DOCUMENT CONTROL LIST  
**Civil Engineering Peer Review**

**Subject: 15 Great Road Apartments 40B Project  
Initial Draft Peer Review Report**

**VILLAGE GREEN  
APARTMENTS  
ZONING  
EXCEPTION PLAN**

**Subject: 15 Great Road Apartments 40B Project  
Second Draft Peer Review Report**

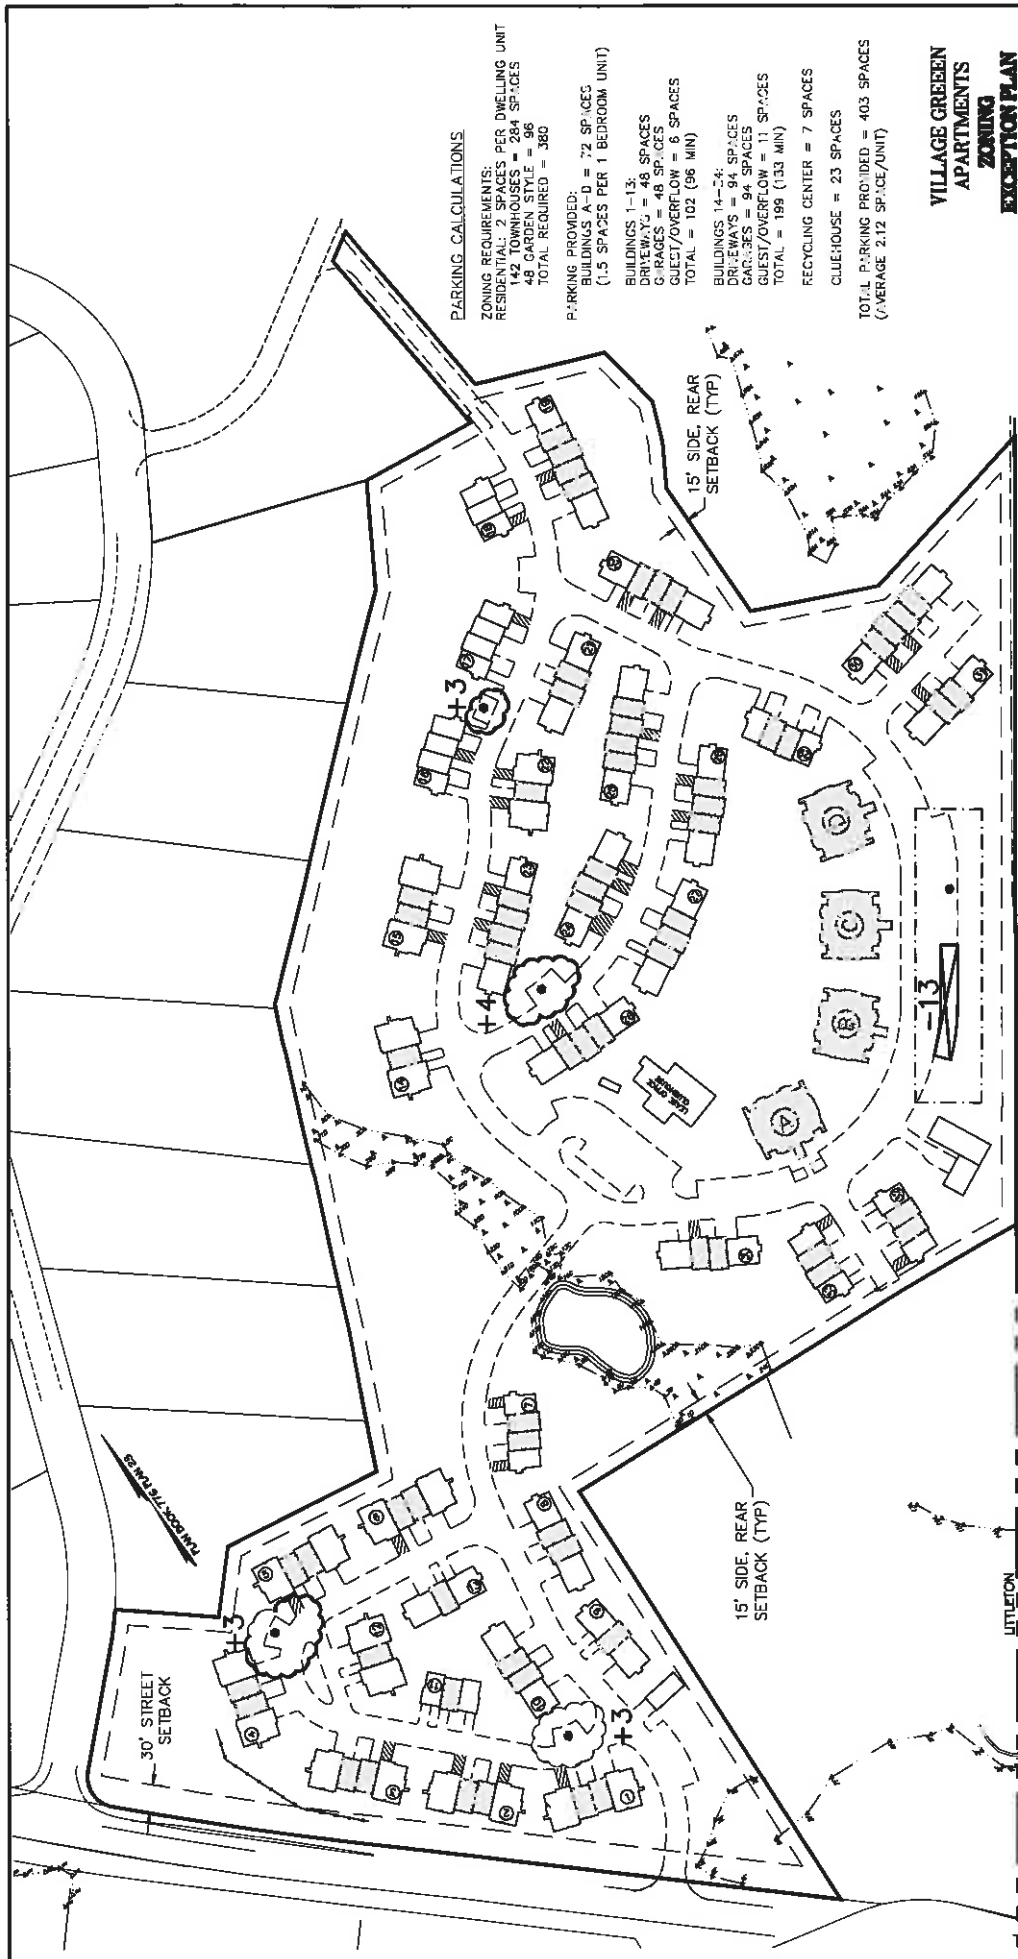
**As presented on the Zoning Exception Plan, "additional parking" was added near Buildings 5, 10, 16 and 26. The Zoning Exception Plan also identifies townhouse driveways that are between eighteen feet and twenty feet in length. There are a total of 297 parking spaces proposed at the townhouse buildings: 142 spaces in the garages, 142 spaces in the driveways and 13 "extra" parking spaces. Of those, 33 spaces (11.1%) are driveway spaces between eighteen feet and twenty feet long. The thirteen "extra" parking spaces account for 4.4% of the parking spaces. The revised parking layout does not appear to be unreasonable. Please see Comment #3 relative to the overall provision for parking at the project. Finally, to clarify the concern for vehicle encroachment, if a Comprehensive Permit is issued, then the Board may wish to consider a condition that prohibits parked vehicles from encroaching on an interior way or sidewalk and/or set a specific minimum driveway length.**

**As presented on the "Zoning Exception Plan", "additional parking" was added near Buildings 5, 10, 16 and 26. The revised parking layout is reasonable and is an improvement to the overall parking scheme. However, the plan also eliminated thirteen parking spaces at Buildings A – D. The new parking layout must be incorporated into the next plan set issued to the Board. Please see Comment #3 relative to the overall provision for parking at the project.**
